Product Change Notification / GBNG-03JWKQ486

CCB 4443 Initial Notice: Qualification of G631HQ mold compound material for selected Atmel AT32UC3Axxx and AT32UC3Cxxx device families available in 144L LQFP (20x20x1.4mm) package at ANAP assembly site.

PCN #: GBNG-03JWKQ486

**PRE AND POST CHANGE SUMMARY
CCB 4443**

Lead frame Comparison

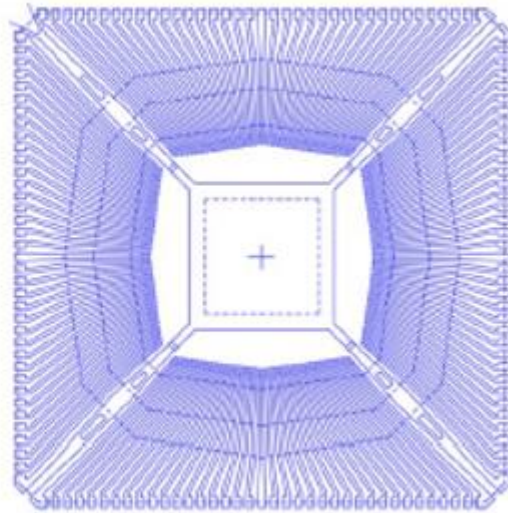
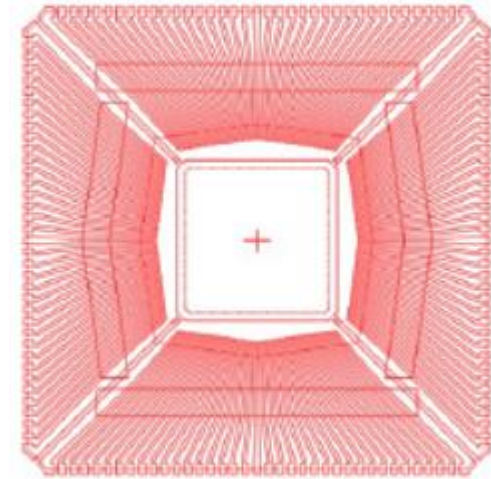
Using G700L mold compound material with 276x276 mils or 236x236 mils lead frame paddle size.

Using G631HQ mold compound material with 276x276 mils lead frame paddle size.

Strip Density	HDLF High Density Lead frame	HDLF High Density Lead frame
LF Paddle Sie	276x276 mils	236x236 mils
DAP Surface Prep	Double Ring Ag	Double Ring Ag
Backside Dimple	Yes	Yes

Strip Density	UDLF Ultra Density Lead frame
LF Paddle Sie	276x276 mils
DAP Surface Prep	Double Ring Ag
Backside Dimple	No
